## XC2300 Derivatives

Errata Sheet

V1.9 2014-10

**Figure 1 Critical application reset sequence**

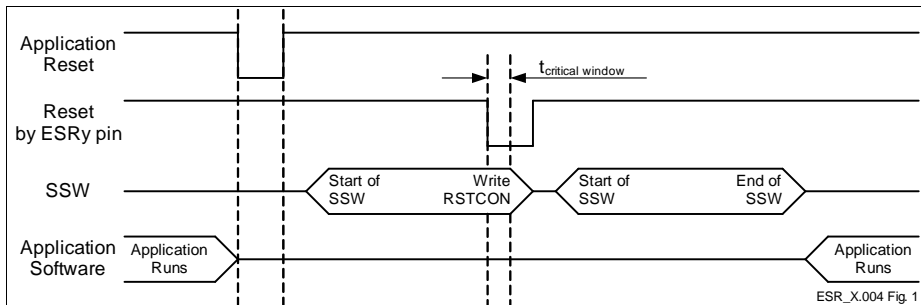
### **ESR X.004 Wrong Value of SCU\_RSTCONx Registers after ESRy Application Reset**

SCU\_RSTCONx registers are reset only by Power-On, but they may be wrongly affected after a second application reset requested by an ESRy pin. This may lead to the SCU\_RSTCONx register values being set to zero, which could unexpectedly disable reset sources within the user application. The conditions which lead to this behavior are:

1. First, an application reset by SW (software), CPU (Central Processing Unit), MP (Memory), WDT (Watchdog Timer) or ESRy (External Service Request y) occurs.
2. Following this, an application reset on an ESRy pin occurs.
3. If the above mentioned ESRy reset occurs during a critical time window of the SSW (startup software), then it's possible that the application will operate with the wrong SCU\_RSTCONx register value. The critical time window occurs when the SSW is writing the SCU\_RSTCONx registers, and at the same time, the ESRy reset request is processed by the reset circuitry. The width of this critical window  $f_{critical\ window}$  is less than 13 cycles.

- Initialize `SCU_RSTCONx` registers by user software after any reset, or
- assure that a second application reset request with an ESR pin does not occur during the critical time window.

**Figure 2 Example for Case 2: Interrupt Service for Task C delayed**

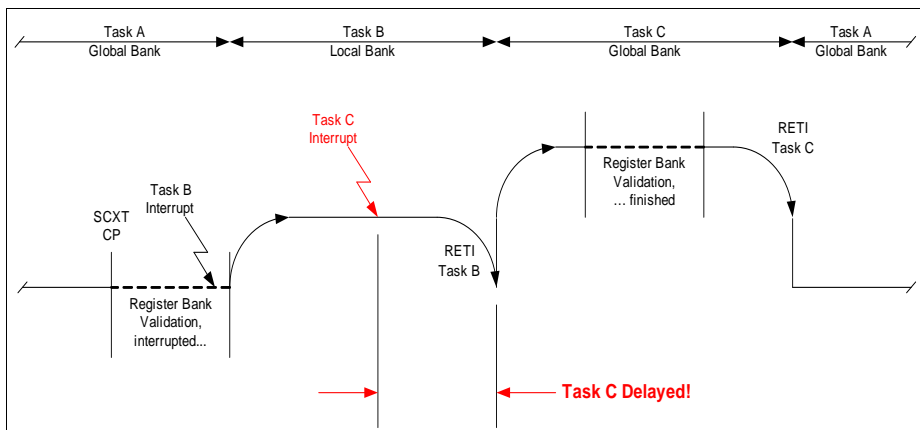
Case 2 (see also Figure 1):

- The Context Pointer CP is written to (e.g. by POP, MOV, SCXT ... instructions) within a routine (Task A) that uses a **global** register bank (bit field PSW.BANK = 00<sub>B</sub>), i.e. the context for this routine will be modified,
- This context switch procedure (19 cycles) is interrupted by an interrupt request (Task B) which is programmed (with GPRSELx = 1X<sub>B</sub>) to automatically use one of the **local** banks via the bank selection registers BNKSEL0...3 (i.e. the interrupting routine has a priority level  $\geq 12$ ),
- Before the corresponding interrupt service routine is finished, another interrupt request (Task C) occurs which is programmed (with GPRSELx = 00<sub>B</sub>) to automatically use the **global** bank via the bank selection registers BNKSEL0...3 (i.e. the interrupting routine has a priority level  $\geq 13$ ).

In this case service of this interrupt request (for Task C) is delayed until bit field PSW.BANK becomes 00<sub>B</sub> after executing the RETI instruction at the end of the routine (Task B) using the local bank.

### **Workaround for Case 2**

When using both local and global register banks via the bank selection registers BNKSEL0...3 for interrupts on levels  $\geq 12$ , ensure that there is no interrupt using a global register bank that has a higher priority than an interrupt using a local register bank.

**Figure 7 External Clock Drive XTAL1**

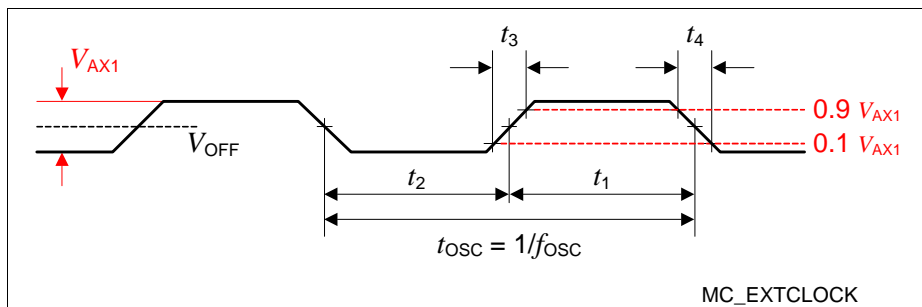
In the Data Sheet section "External Clock Input Parameters" the following table and figure should be updated (major changes are marked **red**).

1) The amplitude voltage  $V_{AX1}$  refers to the offset voltage  $V_{OFF}$ . This offset voltage must be stable during the operation and the resulting voltage peaks must remain within the limits defined by  $V_{IX1}$ .
